ARCHITECT'S SUPPLEMENTAL INSTRUCTIONS

ASI 03

Project: Homestead Community Center & Sales Office
0428
Date: May 10, 2007
To: _____
Owner: DR Horton Continental Series
Contract For: General Construction
Contract Date: _____
From: CCBG Architects, Inc.
Copies To: John Lockett

1. Clarification of dimensions and head configuration at interior openings of Sales Office.
2. Extend wall at mechanical equipment on west side of Community Center.

SK 04

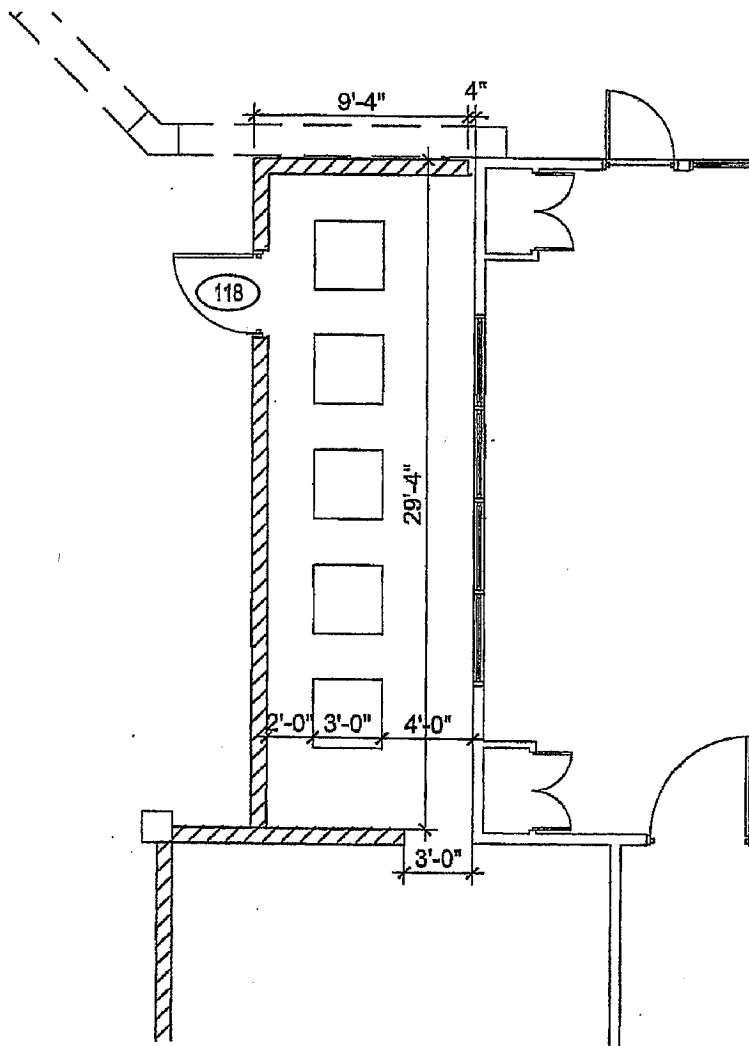
INTERIOR OPENINGS AT LOBBY 100 OF SALES OFFICE SHALL RECEIVE
CHAMFERED HEAD 12" x 12".
